**COUNTY OF SAN MATEO
PLANNING AND BUILDING DEPARTMENT**

SUBJECT: EXECUTIVE SUMMARY: Consideration of an appeal of the Coastside Design Review Committee's decision to approve a Design Review Permit and Grading Permit pursuant to Section 6565.3 of the County Zoning Regulations and Section 9283 of the County Ordinance Code, for the construction of a new 2,771 sq. ft. two-story single-family residence, with an attached 507 sq. ft. two car garage, 330 cubic yards of grading and no tree removal, on a vacant 5,230 sq. ft. parcel, located between 631 and 647 El Granada Boulevard , in the unincorporated El Granada area of San Mateo County.

County File Number: PLN 2019-00162 (Love/Zheng)

SUBJECT: Consideration of an appeal of the Community Development Director's decision to approve a Design Review Permit and Grading Permit, pursuant to Section 6565.3 of the County Zoning Regulations and Section 9283 of the County Ordinance Code, for the construction of a new 2,771 sq. ft. two-story single-family residence, including an attached 507 sq. ft. two-car garage, 330 cubic yards of grading and no tree removal, on a vacant 5,230 sq. ft. parcel, located between 631 and 647 El Granada Boulevard, in

SHEET C-1

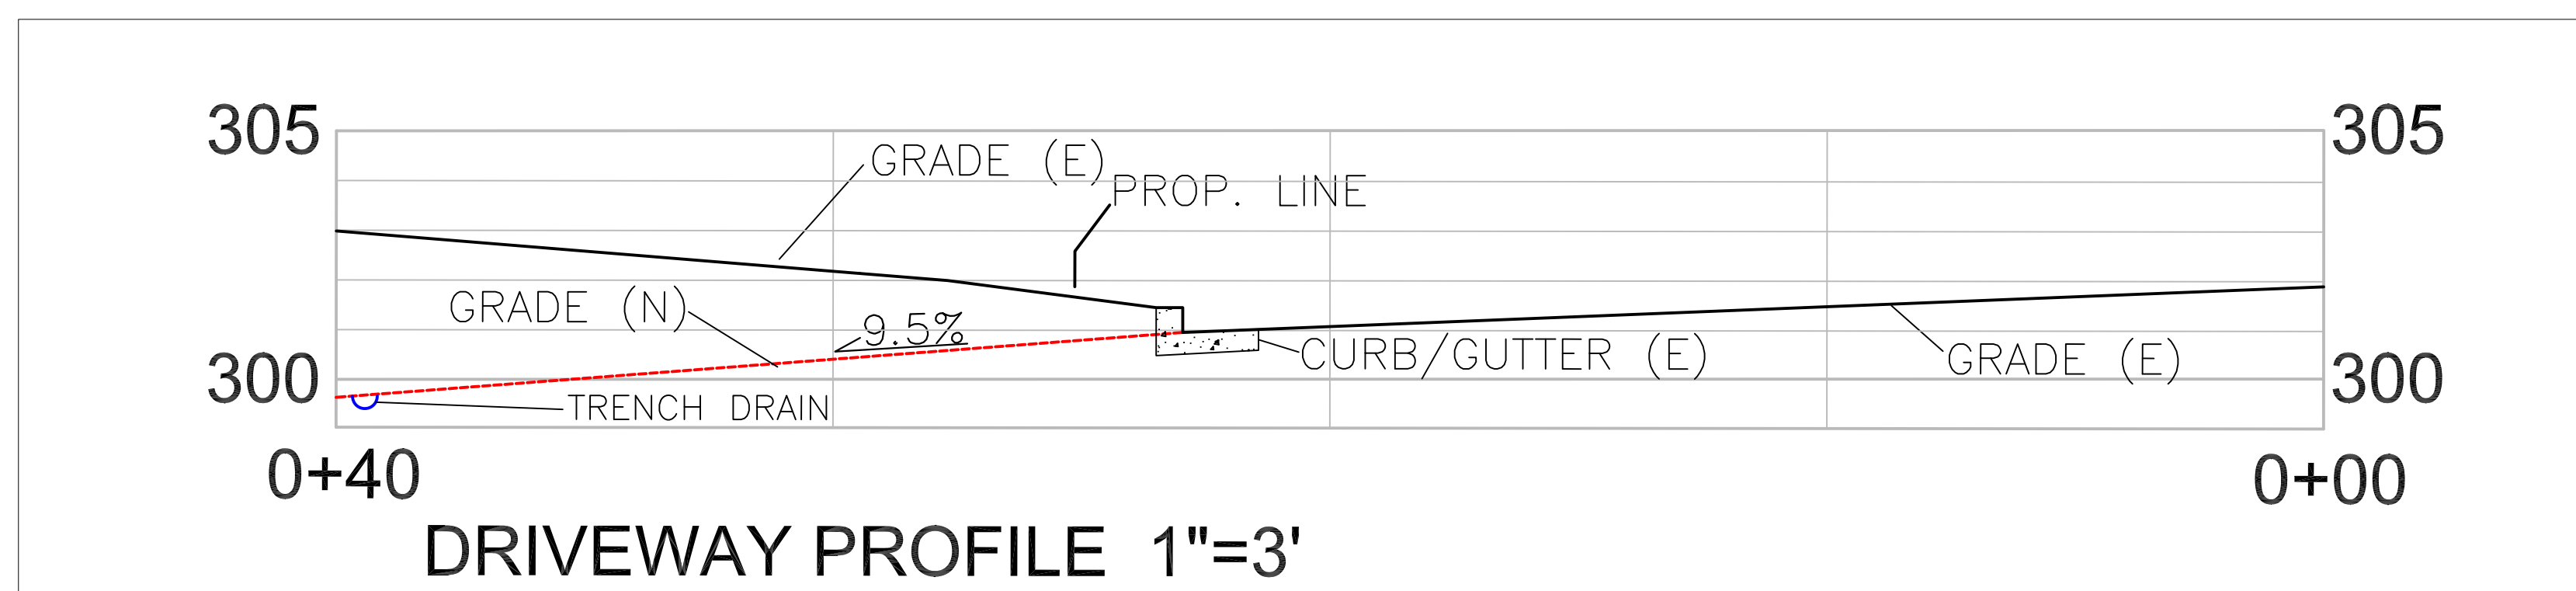
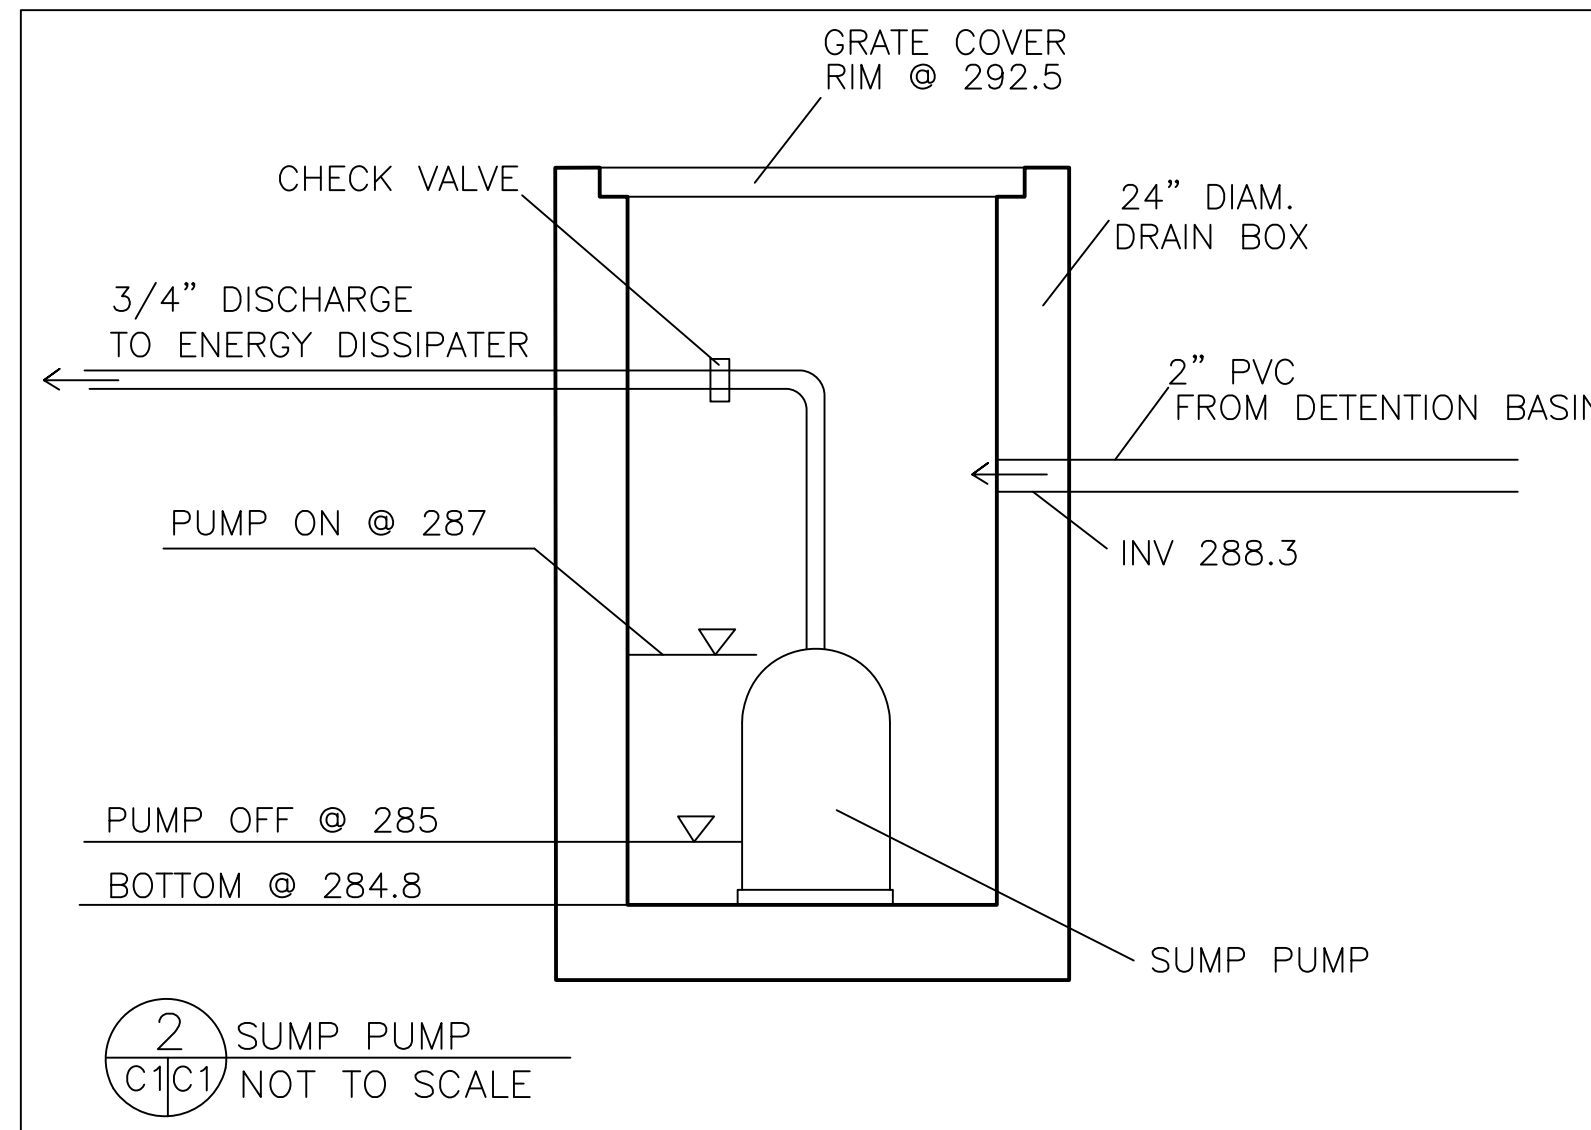
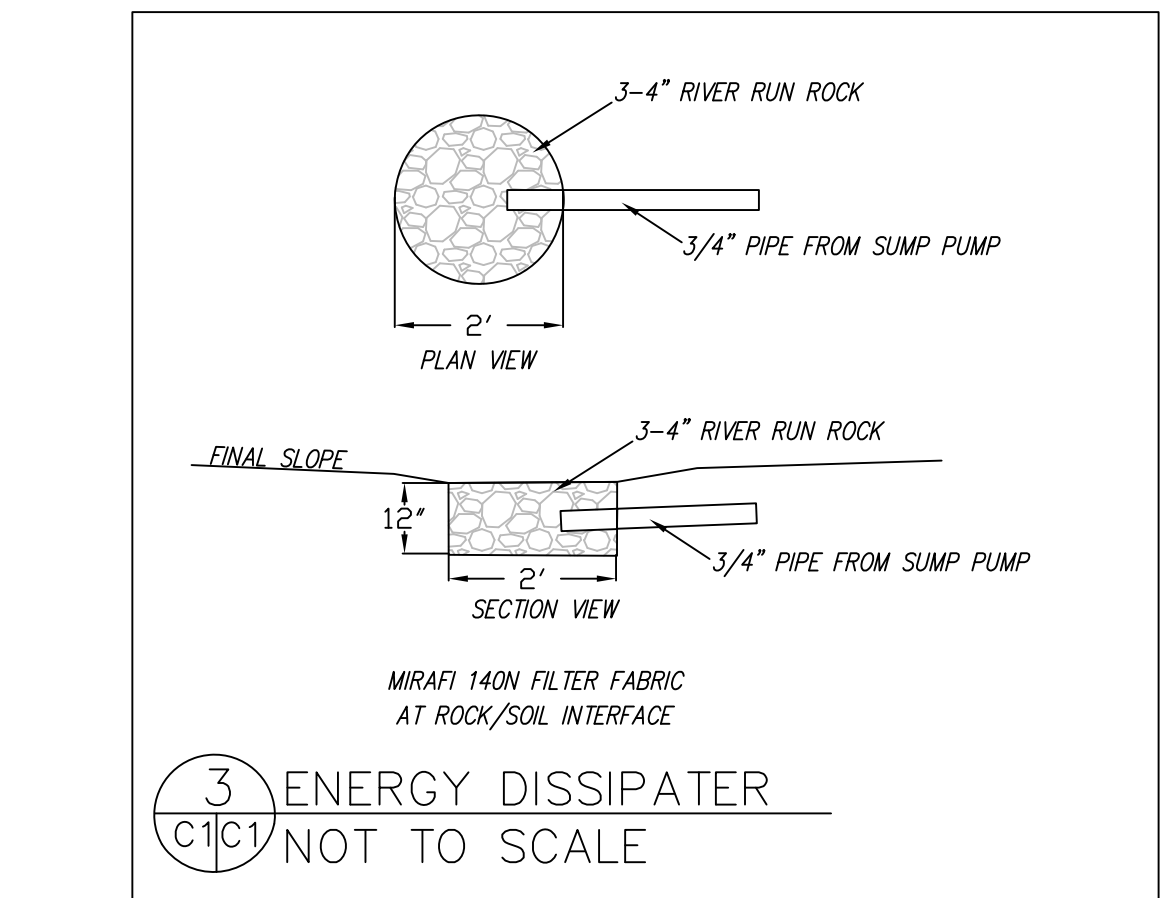
Mr. Zheng's proposed project lacks a sufficient drainage and erosion control system, as detailed in Dr. Upp's expert analysis. See Exhibit 1 (Upp Analysis) at pp. 4-6. Mr. Zheng relied on Mr. Kissick's March 18, 2019 drainage report (**Exhibit 5**) in his plans, particularly on Sheet C-1. However, the drainage plans are not only inadequate per Dr. Upp, but they also fail to comply with the Department's mandate—sent to the applicant on May 21 and 24, 2019—that the detention basin be 23 feet long, whereas the proposed detention basin is now only 13.3 feet long in the proposed plans. See **Exhibit 6** (Accela Report at May 21 and 24, 2019).

What is shown on the Second Revised Grading and Drainage Plan, sheet C-1, dated March 16, 2020 [document **R** above] is a solid 2.5 feet diameter by 13.3 feet long pipe buried in a 3.5 feet wide by 4 feet deep pit filled with gravel. No

project plans (e.g., Sheet C-1) is insufficient to comply with requisite standards. Furthermore, Mr. Zheng's design plans were significantly changed multiple times since Mr. Kissick's July 2019 report. However, the Department wrongly relied on an outdated report prepared by an unqualified engineer in order to approve the project up to this stage. The Department's May 11 Approval Letter indicates that comprehensive geotechnical analysis can *after* the project is moved past the current planning stage, but that is imprudent given that the geotechnical implications directly affect the feasibility of building a large house on a steep hillside.

Staff Response: The proposed Drainage Plan and Drainage Calculations, prepared by the civil engineer, was subsequently revised July 21, 2020, after Planning approval was issued and has been reviewed and granted conditional approval by the Building Division's drainage engineer. The revised drainage system will provide the required protection and complies with the County's drainage requirements. Further, the erosion and sediment control plan has been reviewed by drainage staff and meets County requirements.

SHEET:
A1.03

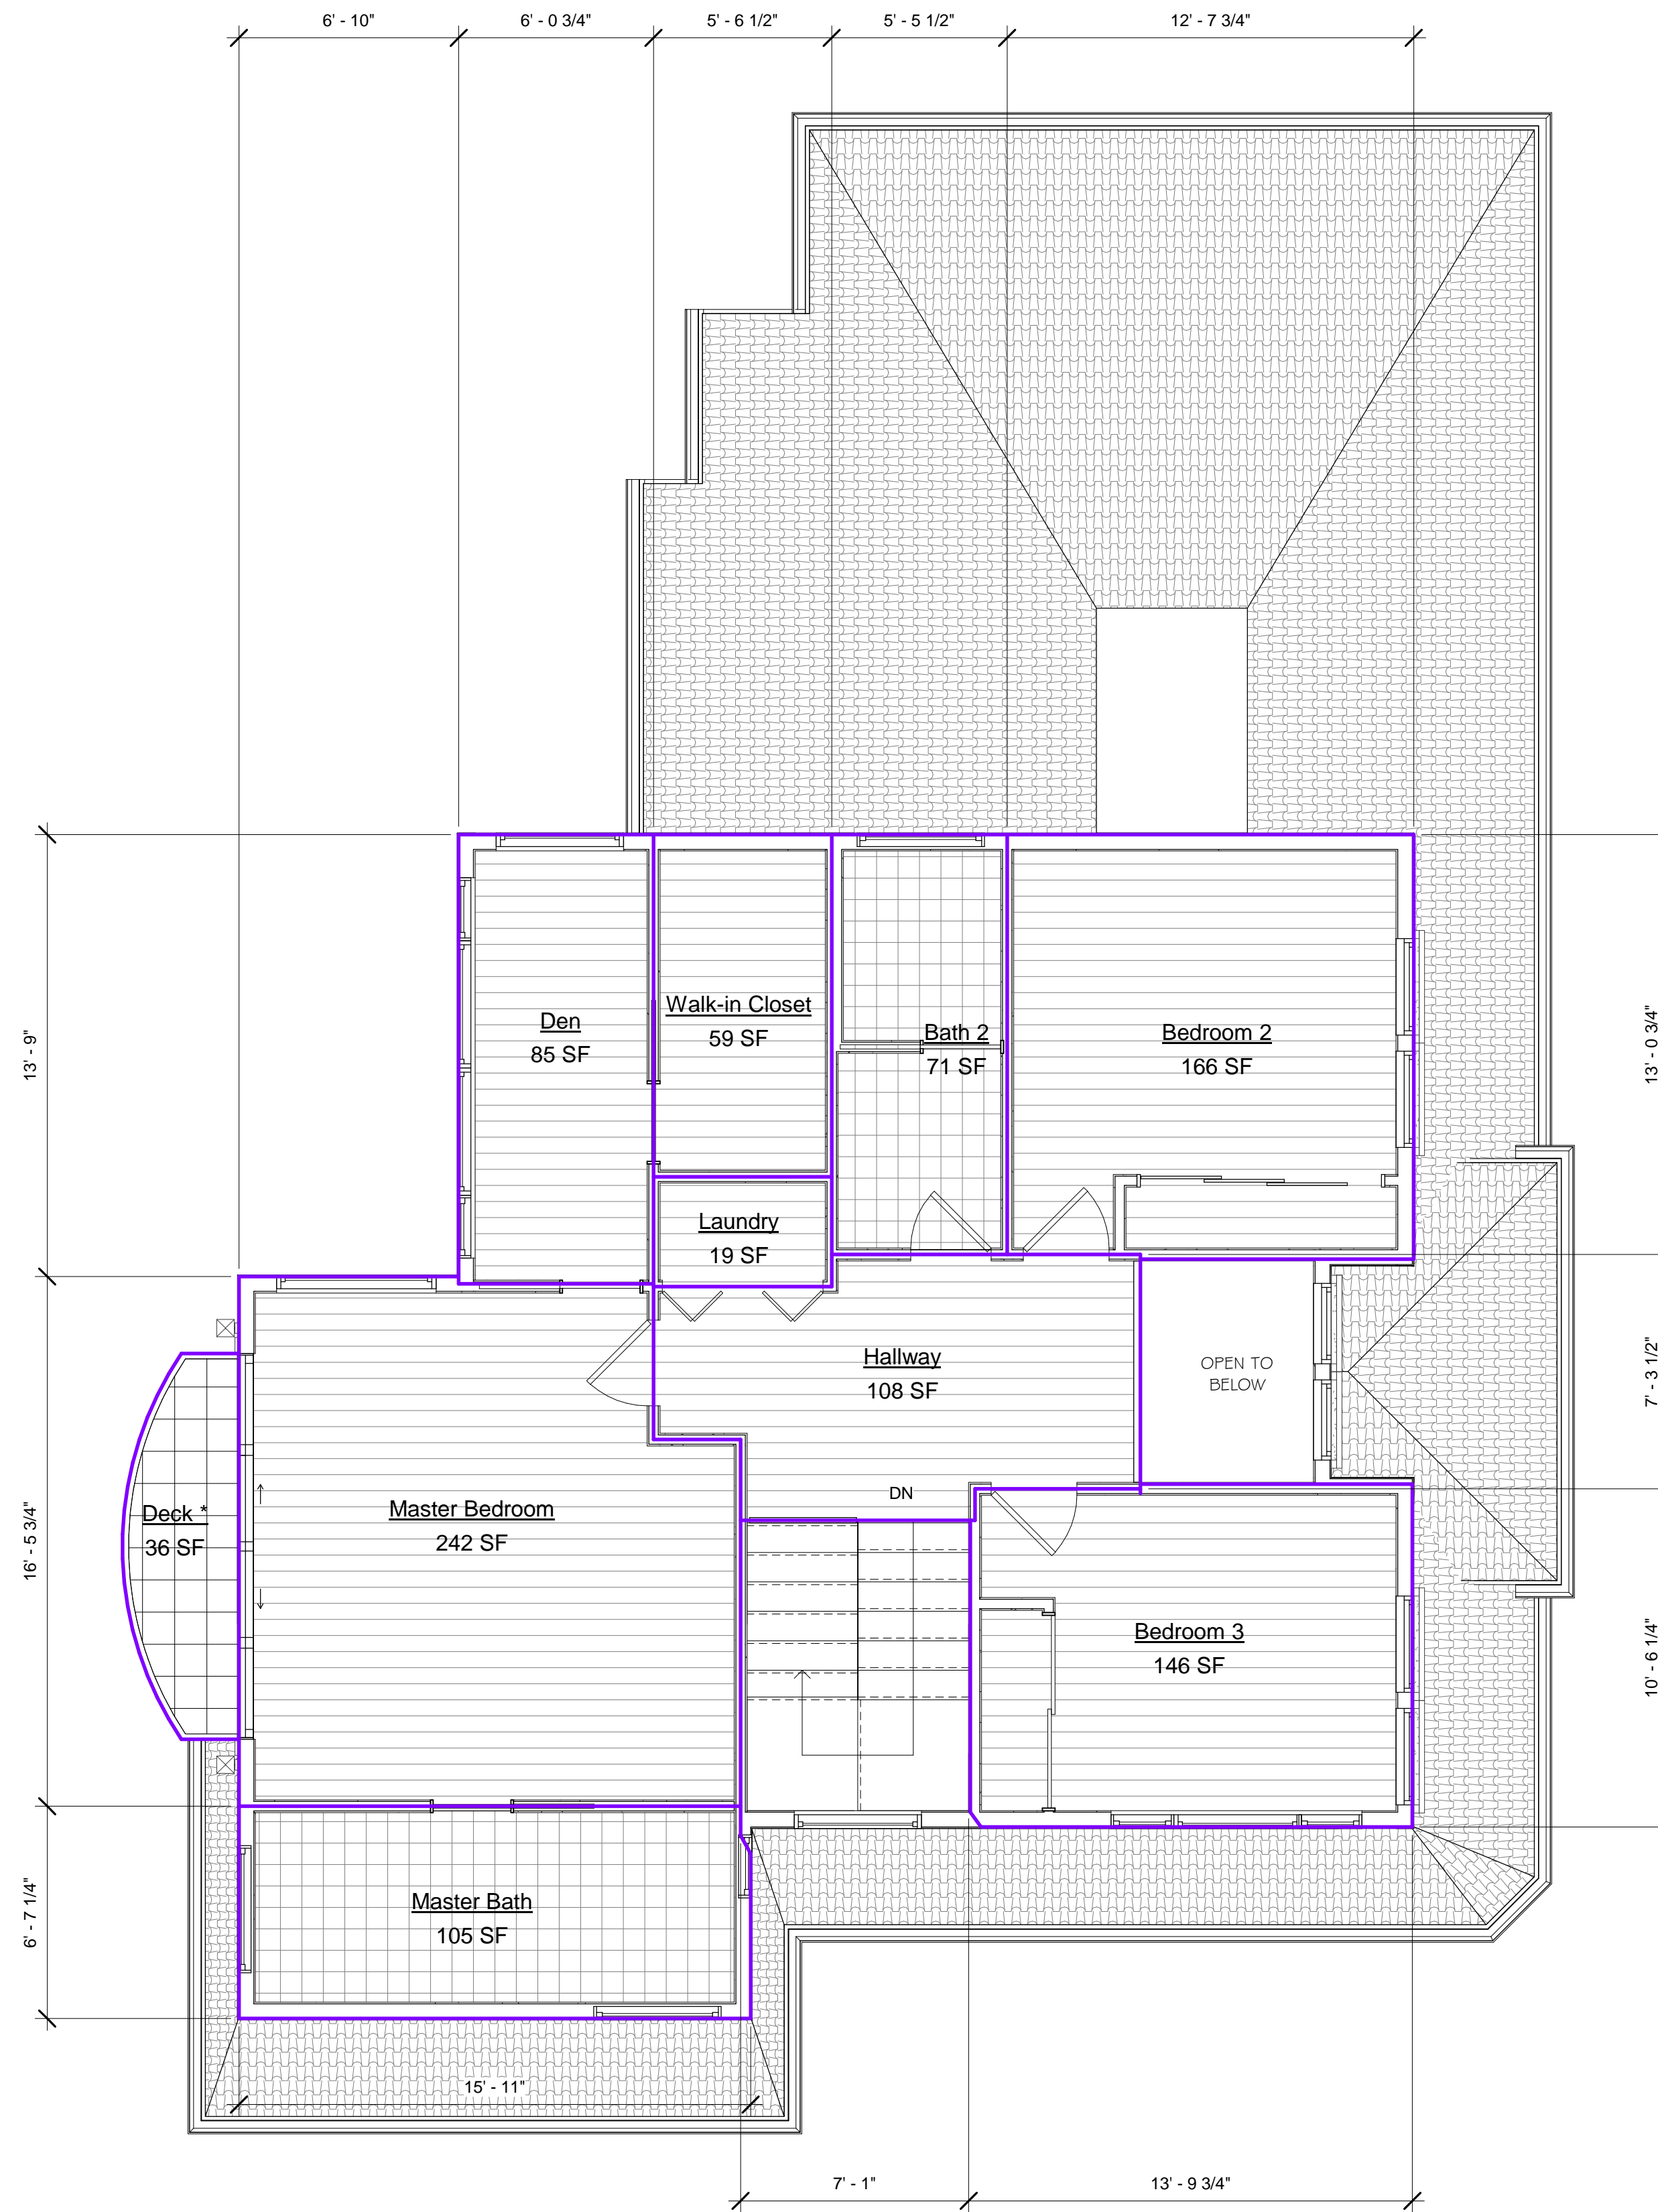
As shown on Sheet A1.03, Mr. Zheng’s revised plans add approximately 30 square feet to the garage—which affects Kayoko Barbour’s side of the property. I do not recall such an expansion being proposed during the February 13 meeting.
